ORIGINATION FORM

Proposed Revisions to a Standard Plans Index
(Please provide all information — Incomplete forms will be returned)

Index Number: 515-052
Sheet Number (s): 5
Index Title: Pedestrian/Bicycle Railing (Steel)

Summary of the changes:

TYPE 2 - CHAIN-LINK (Continuous Infill Panel)

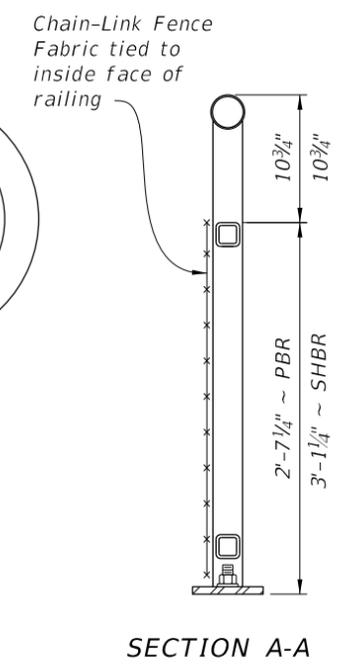
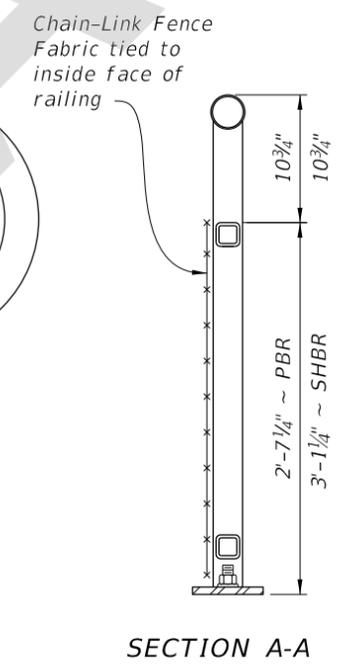
Sheet 5- Added knuckled selvage as an option to the chain-link railing option

The selvage requirements detailed on Index 515-052 were based on a conservative approach to secure the bottom edge. Using knuckle selvage top and bottom would be acceptable.

Knuckled Selvage (Typ.)

Redraw as knuckled

Knuckled Selvage (Typ.)

TABLE 2 - CHAIN-LINK PANEL COMPONENT MATERIALS		
COMPONENT	ASTM	COMPONENT INFORMATION
Chain-Link Fence Fabric (2" mesh with knuckled top and bottom selvage)	A 392	Zinc-Coated Steel - No. 9 gage (coated wire diameter), Class 2 Coating
	A 491	Aluminum-Coated Steel - No. 9 gage (coated wire diameter)
	F 668	Polyvinyl Chloride (PVC) Coated Steel - No. 9 gage Zinc-Coated Wire (metallic-coated core wire diameter) ~ See Plans for specified color of PVC.
Tie Wires	F 626	Zinc-Coated Steel Wire - No. 9 gage with coating to match Chain-Link Fence Fabric.
Tension Bars	F 626	3/16" (Min. thickness) x 3/4" (Min. width) x 2'-3' (Min. height) Steel Bars
Miscellaneous Fence Components	F 626	Zinc-Coated Steel
